**Re: Response to Denial of Remediation Workplan
Site Characterization Report and Remediation Workplan dated May 12, 2020
Holly Energy Partners – Operating, L.P.
Millman Station Crude Oil Release
Approximately 20.5 Miles Southeast of Artesia, Eddy County, New Mexico
Coordinates: 32.66451107, -104.1267756
Incident Number: NRM2002952961**

Response Summary to NMOCD Denial of Remediation Workplan

FIGURE 5

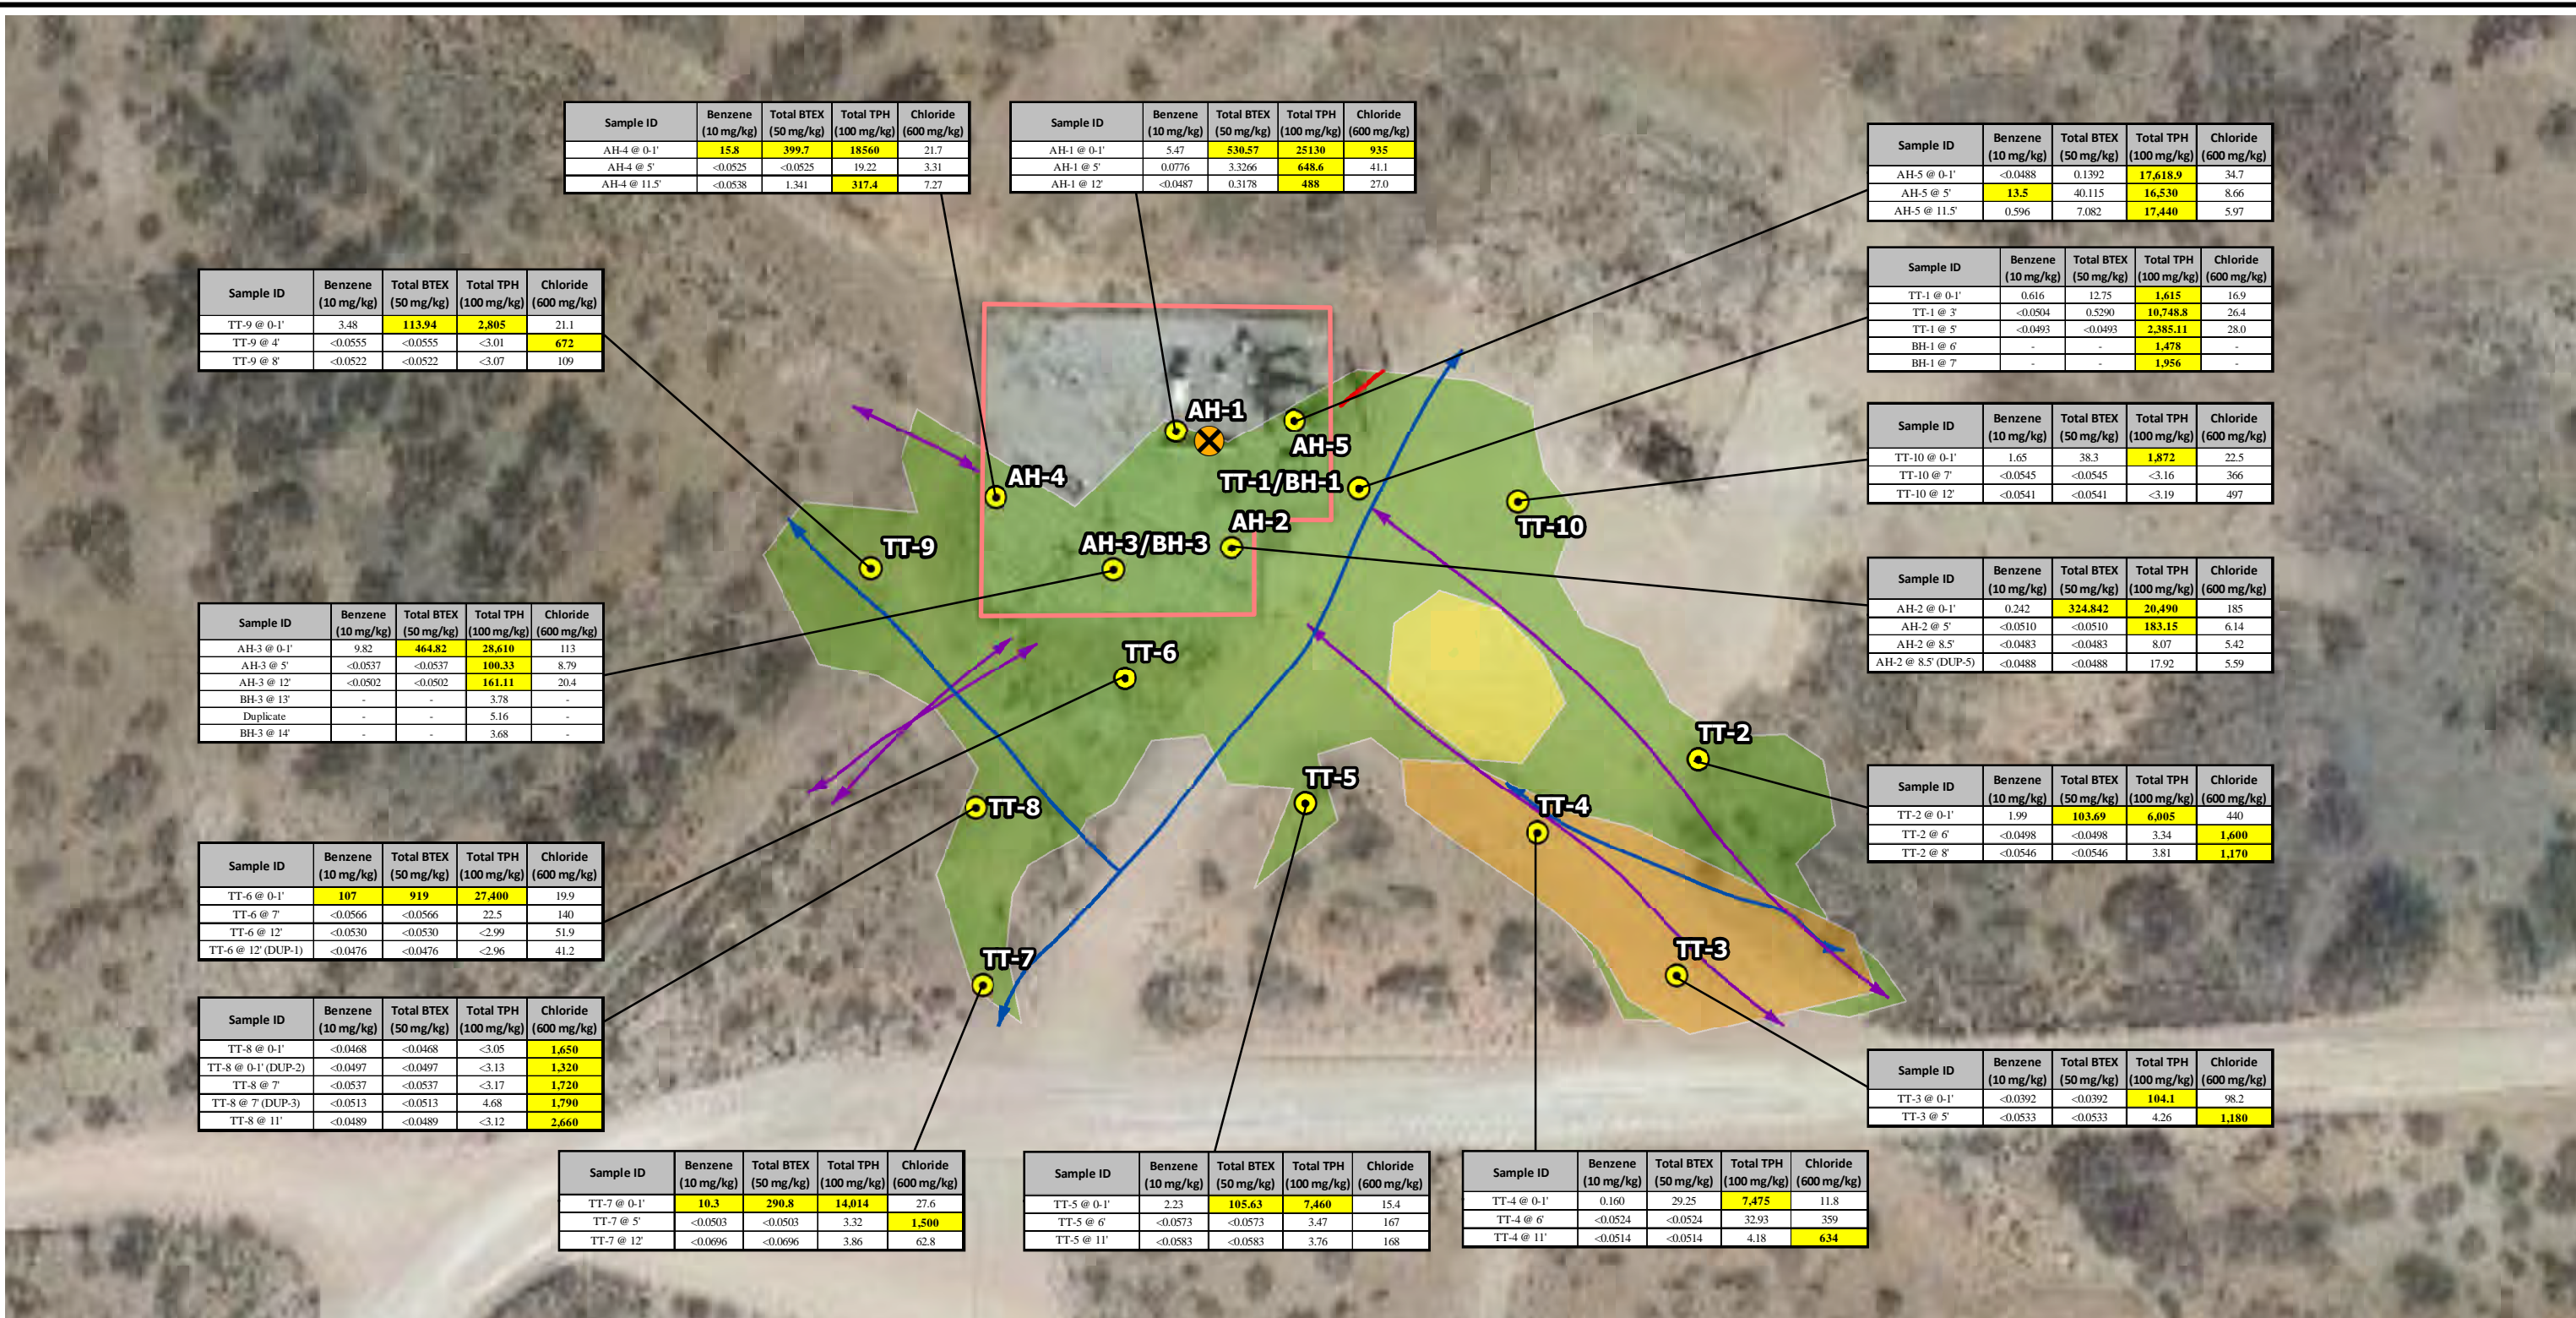
- **NMOCD Comment 5:** *Please continue to horizontally delineate sample points AH-1 and TT-8 to 600 mg/kg for chlorides on the outer edges/periphery and include sample points in your next report after closure criteria limits have been met. Based on distribution of chlorides and TPH, chlorides in TT-8 are not associated with the release and HEP requests no further delineation of what appears to be another operator's affected soil. While vertical definition of contamination that may be acceptable is almost exclusively driven by depth to water, as determined, and as driven by Table I in rule, horizontal definition if different. The edges (horizontal definition) of a liquid release must be determined as well. The only value for determination of horizontal impact are derived by either "background" value as determined appropriate to Rule 29, or, for chloride, 600 mg/Kg in soils. This 600 mg/Kg value is discussed in detail in 19.15.29.13 D. (1). Therefore, horizontal soils delineation for chloride should be 600 mg/KG (again, or background) for all liquid releases, either on or off production pad. It is conceivable that in determining the horizontal extent of chloride that the edge of the production pad may be encountered, if last sample taken on pad limit, samples(s) must be obtained off pad to determine extent of release. If horizontal delineation samples on pad eventually reach a mechanical barrier, (such as pipeline or battery) sample(s) should be obtained as near as possible on the linear opposite side of said barrier and as close as possible to barrier. It is conceivable that a liquid release may occur with, for example, a surface soil chloride of 19,000 mg/Kg, and if it is reliably determined that groundwater is over 101 feet below ground surface, then that value may stand as a vertical definition, but nonetheless, the horizontal value(s) for lateral extent of liquid release would still, of Rule 29 necessity, be 600 mg/Kg chloride or less. This would be inclusive of both "on-pad" or "off-pad" release area. The above if laboratory data driven, not just reported visual extent of a liquid release or calculated and reported release volumes. As indicated in above portions, a scaled map with horizontal and vertical definition of actual laboratory values is required. Generally, the top one foot sample suffices for immediate horizontal evaluation and deeper contamination would likely be identified during actual remediation.*

HEP Response: HEP understands that NMOCD is requesting horizontal delineation of chloride impacts in surface soil at sample points AH-1 and TT-8. Figure 5 from the *Site Characterization Report* and

Remediation Workplan dated May 12, 2020, is attached that shows the sample point locations. HEP concurs with the need to delineate chlorides at sample point AH-1 because there is correlation between the TPH and chloride data, and the location is in close proximity to HEP's release. However, HEP firmly feels the chloride concentrations at sample point TT-8 are not associated with HEP's release for the reasons presented in the *Site Characterization Report and Remediation Workplan* and the additional points presented below. Therefore, HEP should not be responsible for delineating chlorides at sample point TT-8 that are not associated with HEP's release.

- **Vertical Extent:** Sample point TT-8 does not have TPH or BTEX exceedances and most of the data reported non-detect concentrations for TPH and BTEX. This indicates that sample point TT-8 was not impacted by HEP's release as HEP's release contained TPH and BTEX (reference data from sample point AH-1 near the release location). Sample point TT-8 exhibited the deepest chloride exceedances from 0 to 11 feet bgs, as well as the highest detected chloride concentrations. The TPH and BTEX exceedances from the HEP release were constrained to the upper soil profile (0-1 feet) in the sample points located further from the HEP release with exception of sample point TT-8 that does not indicate any impacts from the HEP release. This data clearly indicates that sample point TT-8 was not impacted by HEP's release and that the chlorides at sample point TT-8 were not associated with the HEP release given that there is no correlation between the TPH/BTEX and the chloride data. The most likely source of the chlorides at TT-8 is the line handling produced (brine) water from oil and gas production operations located within 20 feet of sample point TT-8.

Total TPH vs. Chloride Concentration Holly Energy Partners - Operating, L.P. Millman Station Crude Oil Release

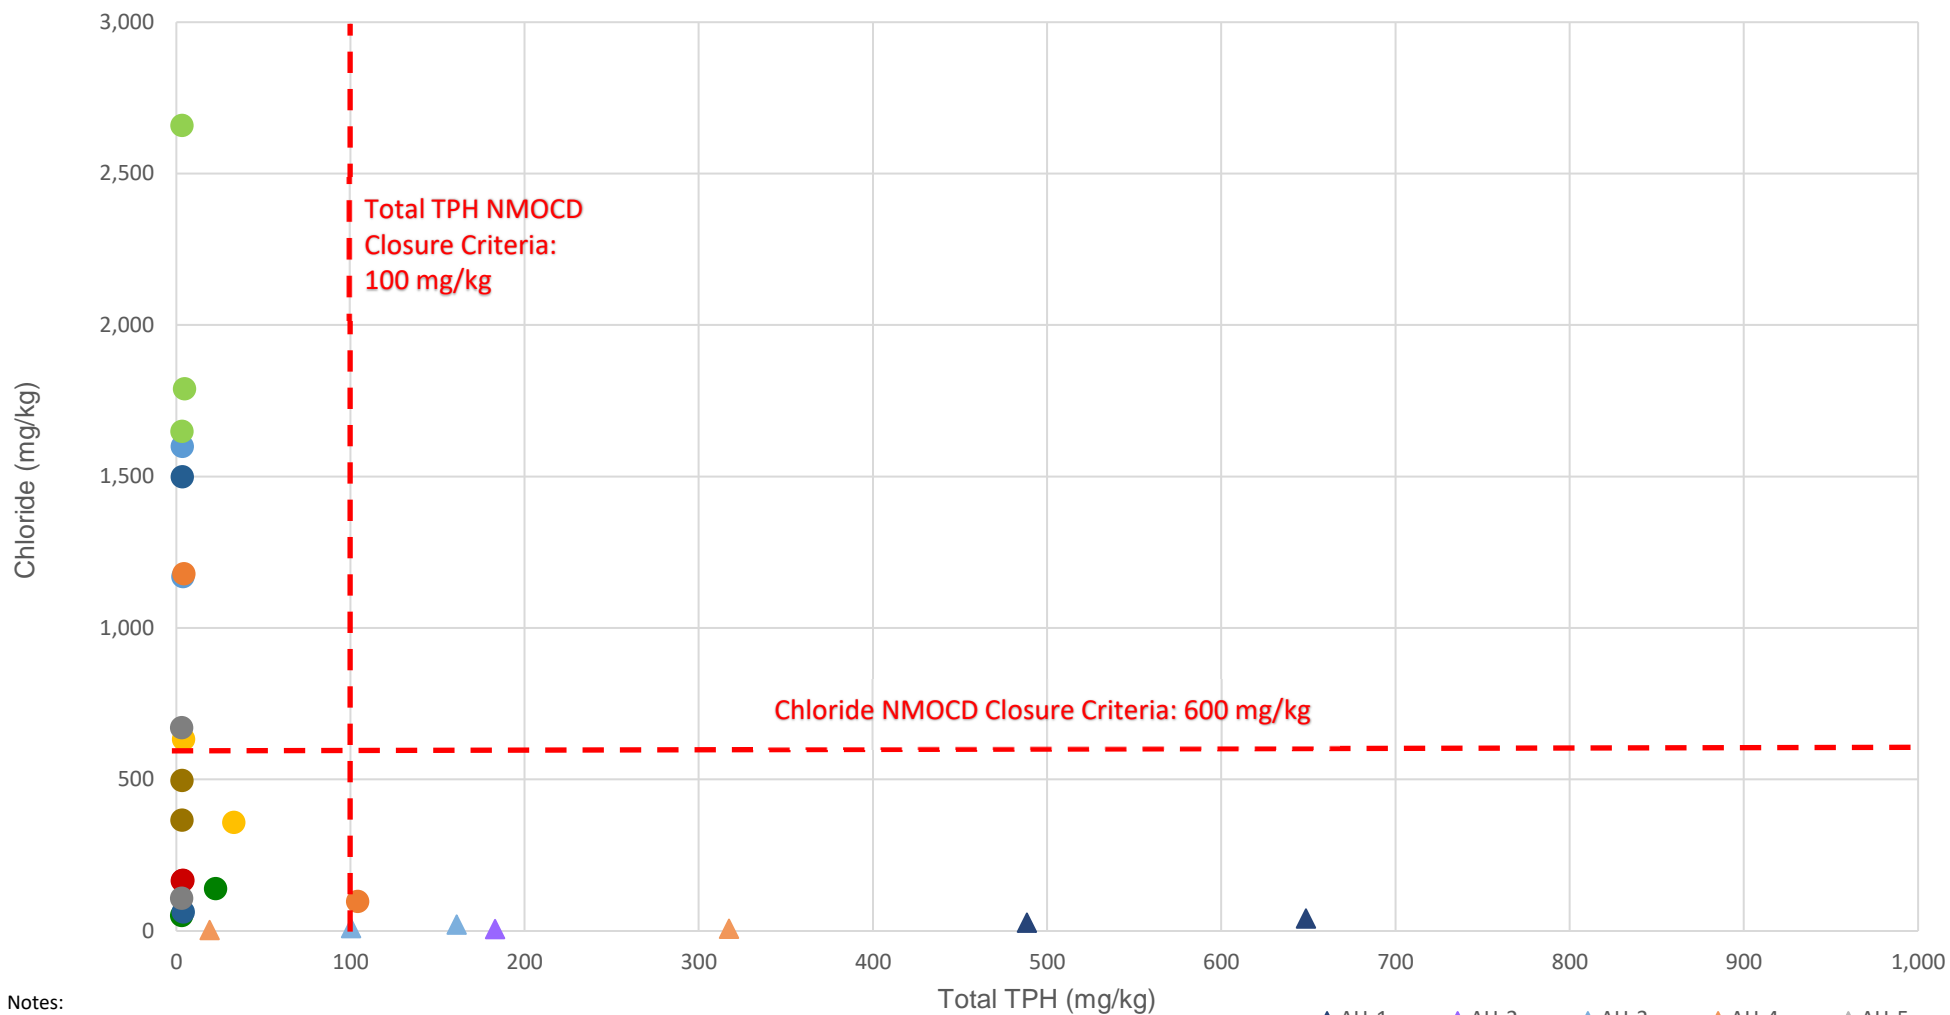
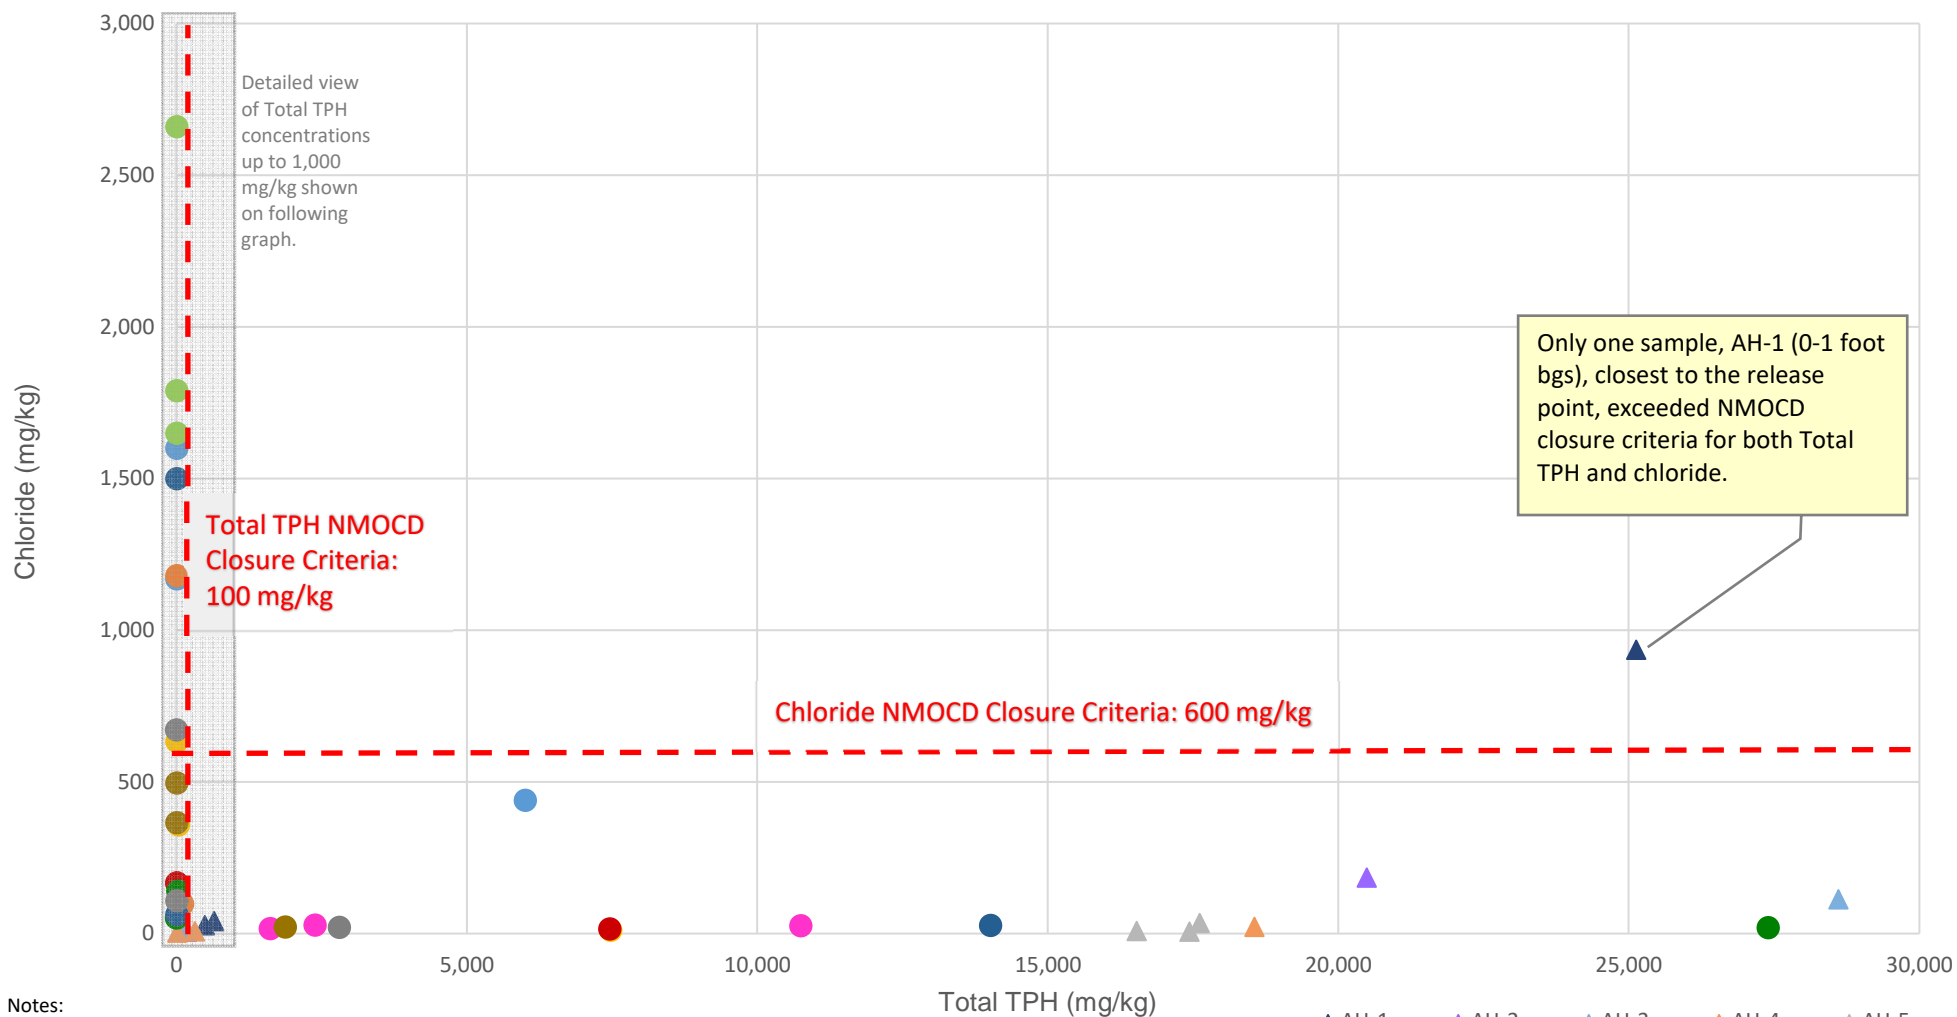
- **TPH-Chloride Inverse Correlation:** The correlation of chloride and TPH concentrations were evaluated across the site with the premise that if chlorides were sourced from HEP's release, then chloride would correlate with TPH, which was sourced from HEP's release. However, there is an inverse correlation of chloride and TPH concentrations as shown on the attached graphs. This indicates that HEP's release, as evidenced by TPH, did not result in the chloride concentrations detected across the site including sample location TT-8. There are numerous produced (brine) water lines in the area of HEP's release that are the likely source of the chlorides.
